Architectural Review Board Staff Report

Meeting Date: September 9, 2021

Location: 18481 Outlet Blvd.

Description: **Chesterfield Blue Valley, Lot 1G SDSP:** A Site Development Section Plan, Landscape Plan, Lighting Plan, Architectural Elevations and Architectural Statement of Design for a 4.32-acre tract of land located along the east side of Outlet Boulevard, north of its intersection with Olive Street Road.

Figure 2: West Elevation

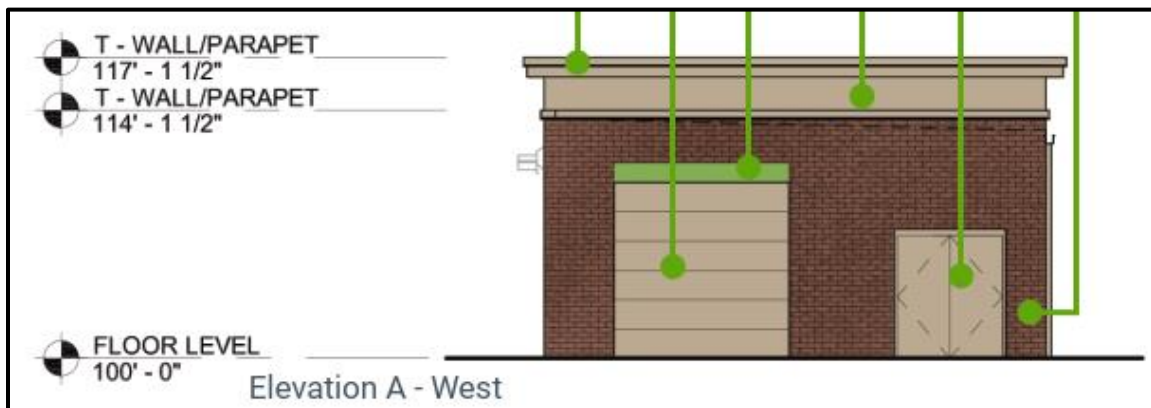
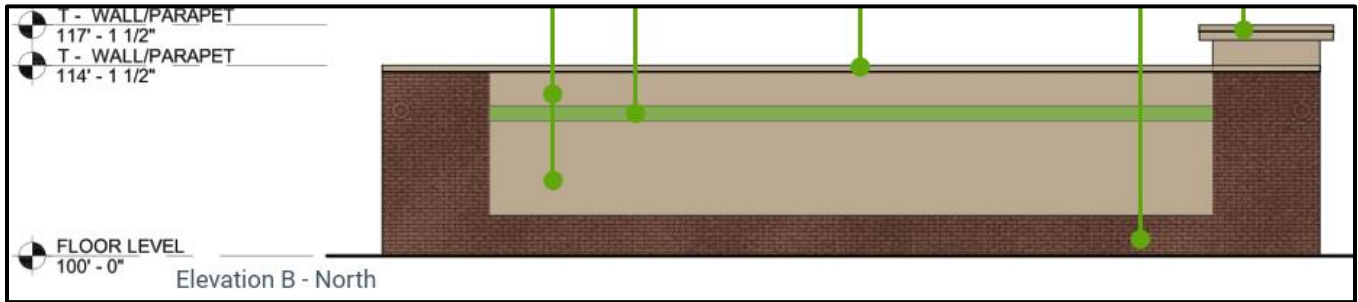
Carwash (Revised)

The building design of the carwash has been revised to incorporate a three-foot (3'0") parapet feature and cornice above the entrance on the north elevation. Brick veneer has also been added to all sides of the building to break up the EIFS that is also utilized on all sides. A green accent band has been added over the vehicular entrances on both the east and west elevations as well as along the upper portion of both north and south elevations to match the color palette of Lot 1H.

Figure 4: Fence Detail

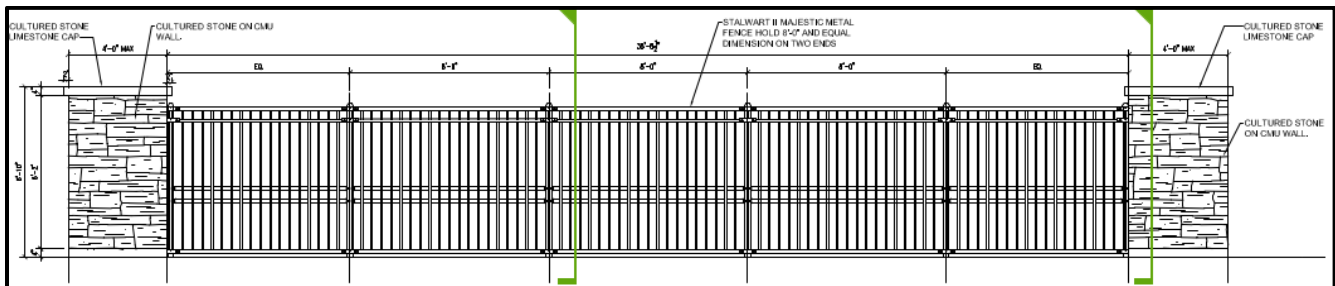
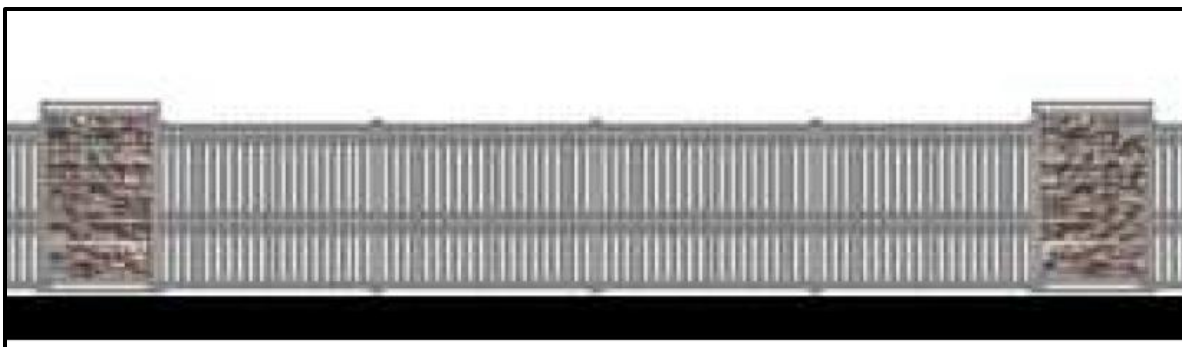
Screening along I-64 (Revised)

The initial ARB submittal for this project included a 12'-15'-high screening wall to accommodate city requirements to screen both outdoor storage of vehicles on Lot 1G and an overhead door on the building of Lot 1H comprised primarily of CMU with stucco and brick-style EIFS finishes.

Since being reviewed at the August 12, 2021 ARB meeting, the required screening for this site has been revised to use a 6'6"-tall decorative metal fence with 6'10" piers featuring a stone veneer finish matching that found on the building of Lot 1H. Each stone pier will measure 4'0" wide and approximately 1'0" in depth with a limestone cap atop each of them. Landscape has also been enhanced along the fence system to soften the appearance of the site while also providing additional screening with deciduous, evergreen and ornamental plantings. The figure below details the design of the revised screening fence. A cross-section of this fence and breakdown of its materials are included in the ARB packet.

Figure 8: 2'6" Bollard Fencing Detail

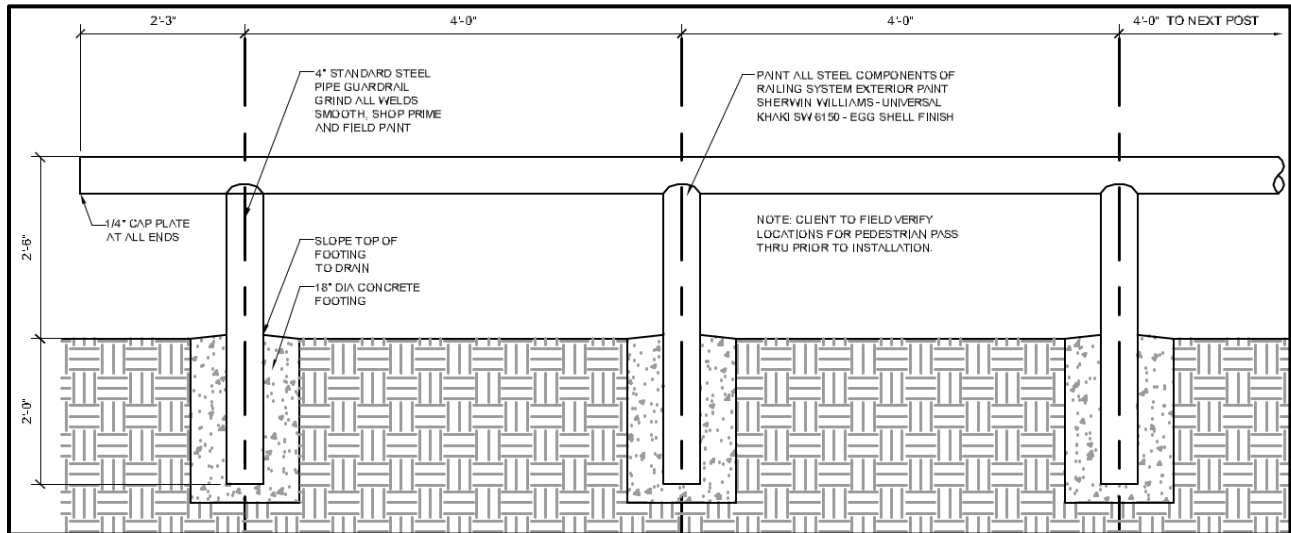
The parking area will feature a two-foot, six-inch (2'6") bollard fence surrounding a large portion of the site's parking area with gated access to this lot on the east and northwest sides. Notably, this bollard fencing will extend across 220 linear feet of pavement on both the north and south sides of the carwash. A detail of this bollard fencing is illustrated in Figure 7 below. A photo example of this bollard fencing is included in the ARB packet. The two (2) gates entering this inventory parking area will stand 6'0" at their highest point and will not be illuminated. A photo example of this gate and a detail are both found in the ARB packet as well.

Chesterfield Blue Valley's Design Package requires a prairie-style design for buildings. The proposed bollard fencing is not outlined in Chesterfield Blue Valley's Design Package and is not found elsewhere in the subdivision.

Figure 9: Landscape Plan

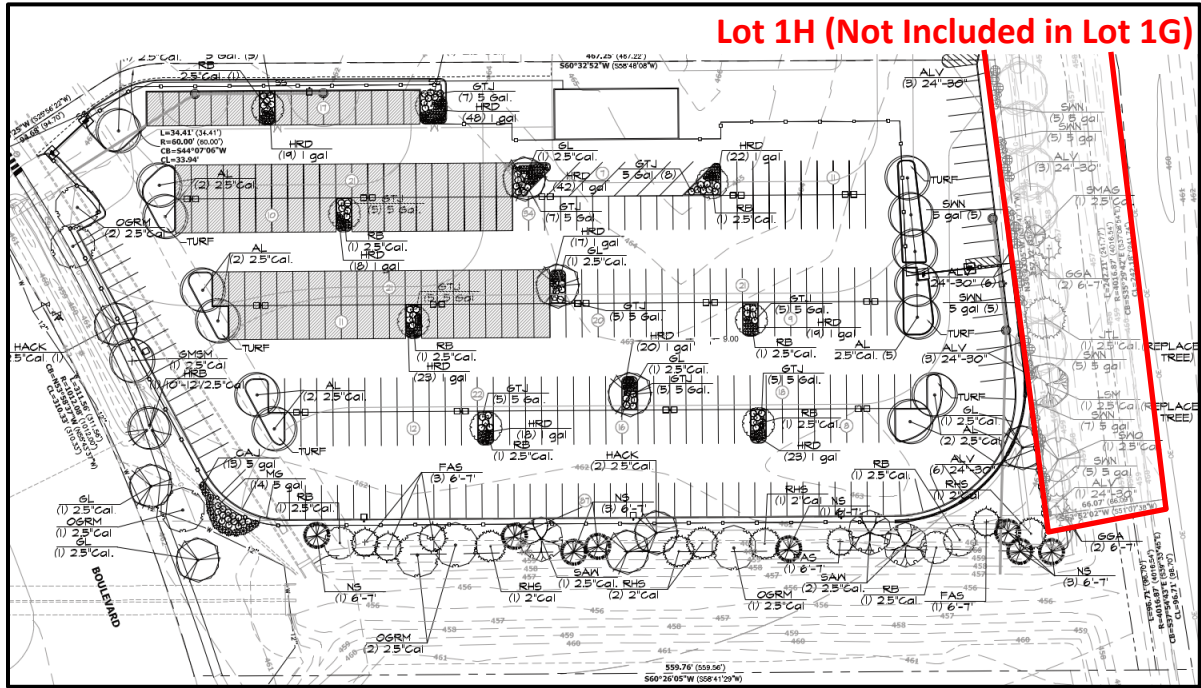
As noted earlier, Ordinance 2805 requires screening of outdoor sales from external roadways for this development. The UDC Architectural Review Design Standards also require the screening of loading areas and outdoor storage of automobiles from I-64. The combination of the screening wall and landscaping along the eastern property line of 1G are intended to adequately screen the outdoor inventory parking area and carwash exit door. It is also intended to screen the overhead doors on Lot 1H from I-64 as well.

The applicant has proposed a mix of trees and shrubs along the screening wall on the northeast property line to soften the appearance of the wall, and continuing around the east corner before continuing along the southeast property line. However, most of the landscaping provided in this area is actually located on adjacent Lot 1H, as highlighted in red in Figure 8 below. Since these lots are separate, review of Lot 1G should not include elements proposed on Lot 1H, which was already reviewed by ARB at the August 12, 2021 meeting and did not include these plantings at the time.
